Service Info

Renault ** - 228 0121 10 280/280 TGU6

New design / Neues Design / Nouvelle conception / Nuevo diseño / Nuovo disegno

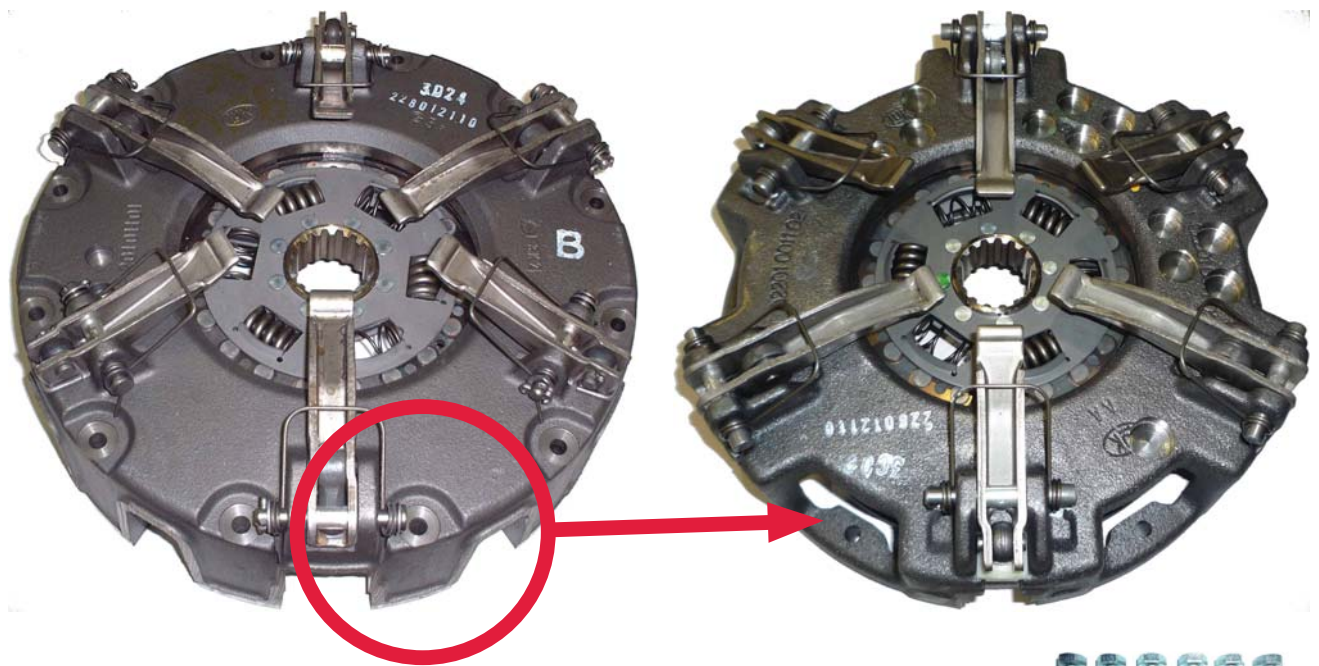
This new design utilises the latest clutch technology, using a vented housing for improved cooling and heat dispersal.

**Fully interchangeable with existing clutches with no modifications required to the vehicle or flywheel.
New fixation bolt set 6 x M8 x 1.25 x 50mm is supplied with new designs to accommodate the lower housing.**
